REDLANDS SUBDIVISION, PHASE 2

APPLICATION NUMBER 3 DATE May 17, 2018

REQUEST Subdivision

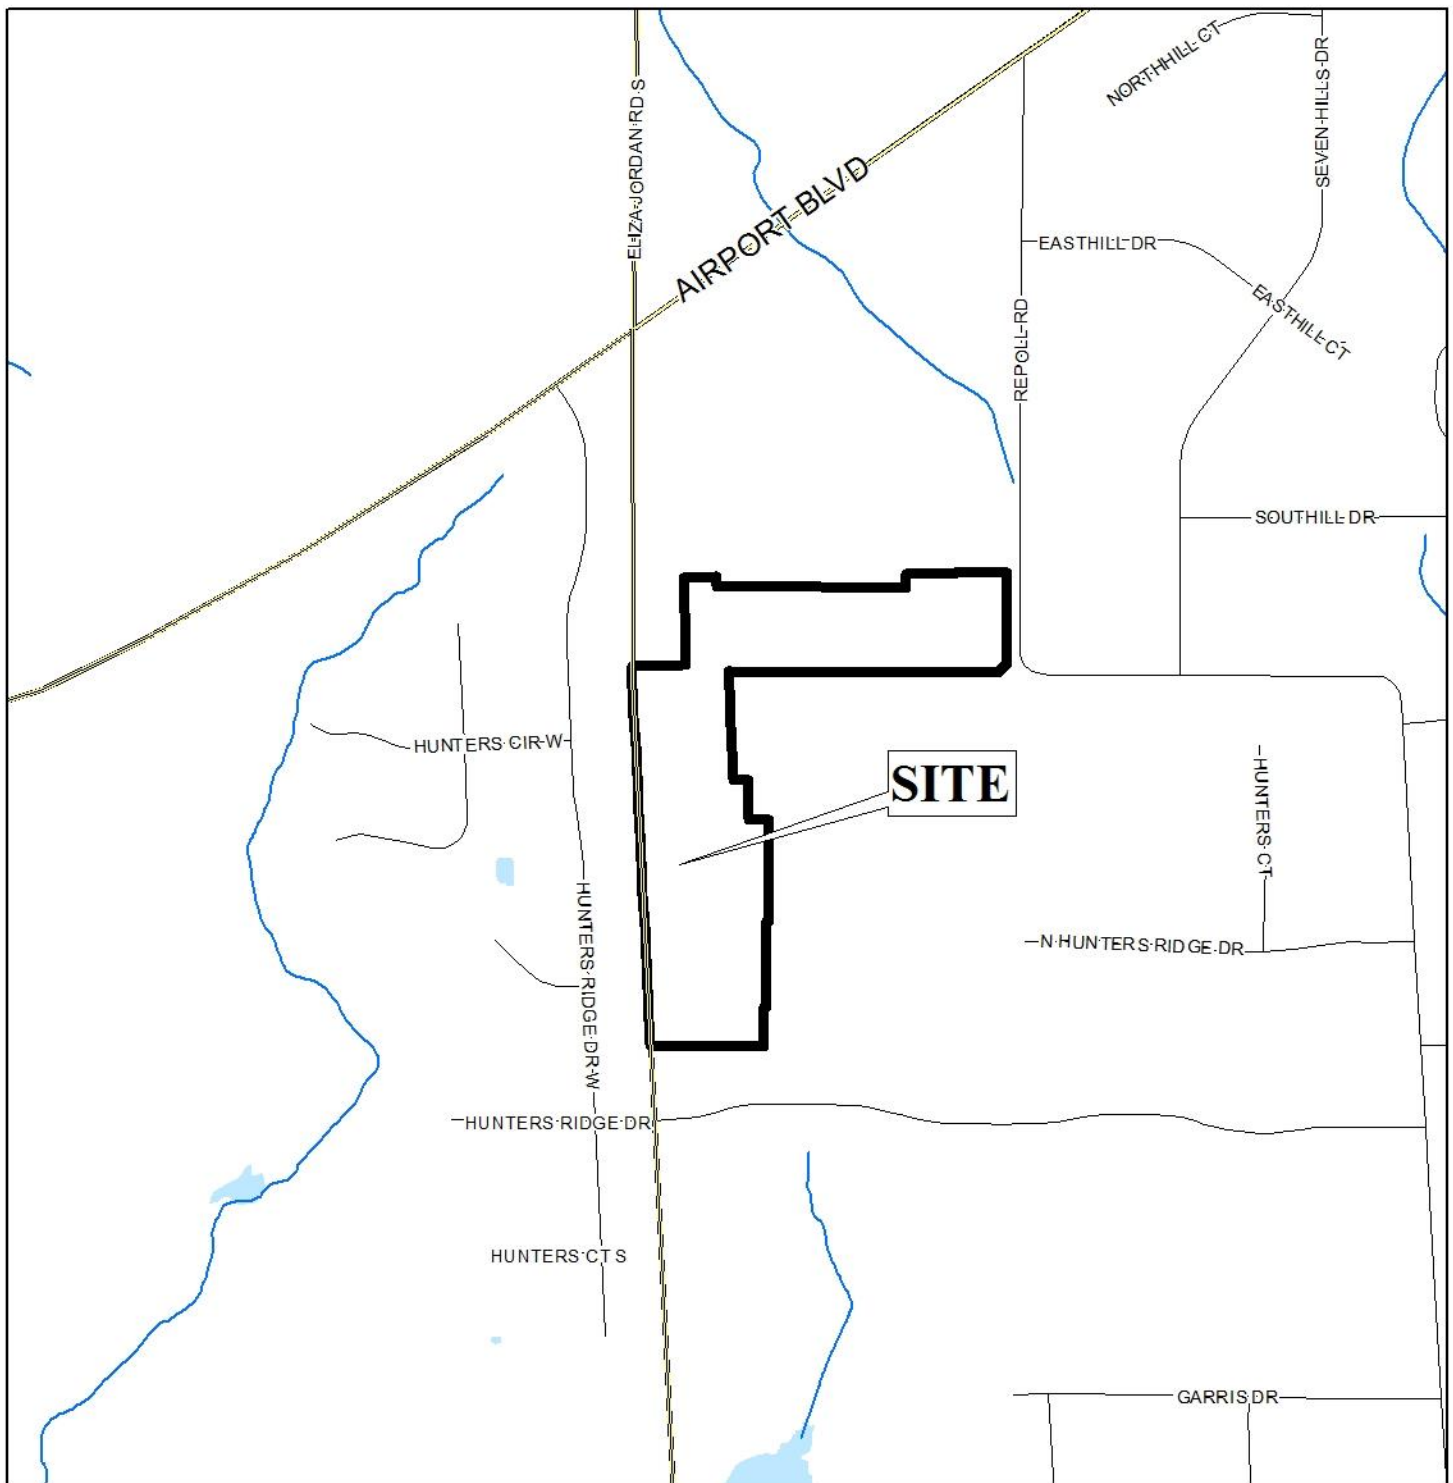
The application was heldover from the April 19th meeting at the applicant's request, so that the applicant could revise the preliminary plat to reflect an entrance across from Eliza Jordan Road, to be coordinated with Mobile County Engineering, and provide a revised composite plan for the entire subdivision, depicting all phases. The applicant did provide a revised preliminary plat for the Redlands Phase 1, & 2 Subdivision depicting an entrance across from Eliza Jordan Road, however a composite plan for the overall subdivision was not submitted.

It should also be noted that a revised plat depicting revisions for the Alabama Pecan Subdivision, Phase 1 has not been submitted. Thus staff has no information regarding how the Alabama Pecan Subdivision was redesigned, nor the proposed lot arrangement. Condition number eight in the Letter of Decision for the Alabama Pecan Subdivision, Phase 1 states the following, "Completion of the subdivision process for the Alabama Pecan Subdivision, Phase 1, prior to bringing in any subsequent subdivision requests for completion (Redlands Subdivision, any phase)". Conditions of approval must be met for the Alabama Pecan Subdivision, Phase 1 prior to moving forward with the Redlands Subdivision as the additional subdivision is contingent upon the Alabama Pecan Subdivision layout.

Based on the fact that a revised composite plan for the entire subdivision has not been submitted, and a revised plat for the Alabama Pecan Subdivision, Phase 1 has not been received, as they were both requirements per the Letters of the Decision, staff can not recommend the subdivision for approval.

Based on the proceeding, the application is recommended for denial for the following:

- 1) Per the Letter of Decision of approval of the Pecan Subdivision, Phase 1, item number 8 states” Completion of the subdivision process for the Alabama Pecan Subdivision, Phase 1, prior to bringing in any subsequent subdivision requests for completion (Redlands Subdivision, any phase)”;* and
- 2) No overall conceptual plan depicting all proposed phases of development for the Redlands Subdivision was provided, as requested.*
